S E R V I C E N O T E

**11792A Sensor Module (Std/Opt 001)**

**Serial Numbers:** 0000A00000 / 2814A01331

**New Coaxial Switch Requires New Mounting Hardware**

Figure 1. Mechanical and electrical connections

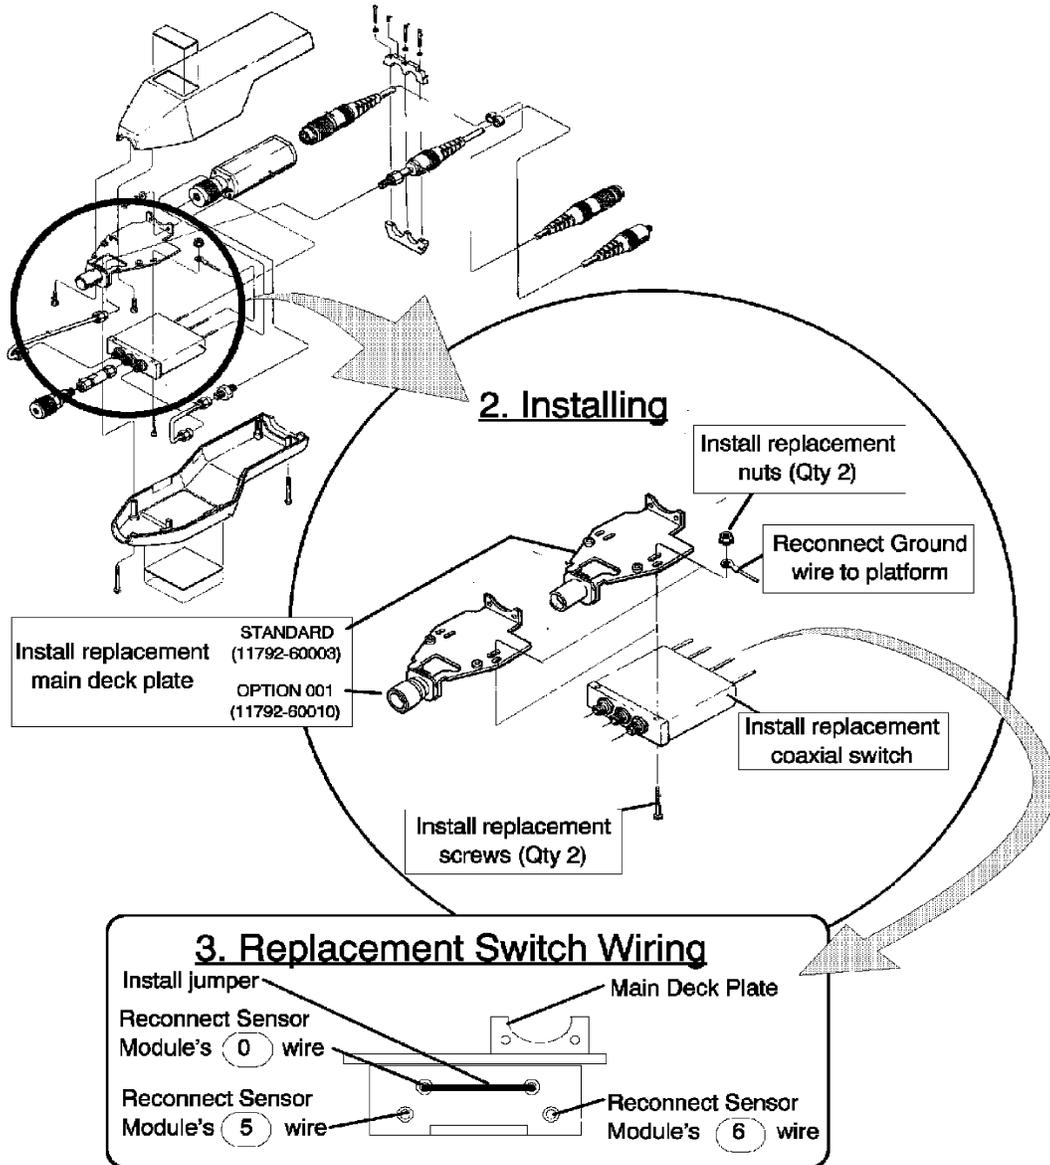
When replacing Coaxial Switch S1 in a 11792A (for serial numbers noted above), replacement of the Main Deck Plate MP1 and associated hardware is required. The new Coaxial Switch (11792-60012) is more reliable and has improved repeatability than the old switch. The part number of the new switch is the same as the old switch. The part number(s) of the replacement Main Deck Plate are the same as the original Main Deck Plate.

Replace original Main Deck Plate MP1 and associated hardware with part numbers (depending on option) noted above. Refer to Figure 1 for correct mechanical and electrical connections. Re-calibration and generation of Calibration Factors for the Sensor Module is recommended after coaxial switch replacement.
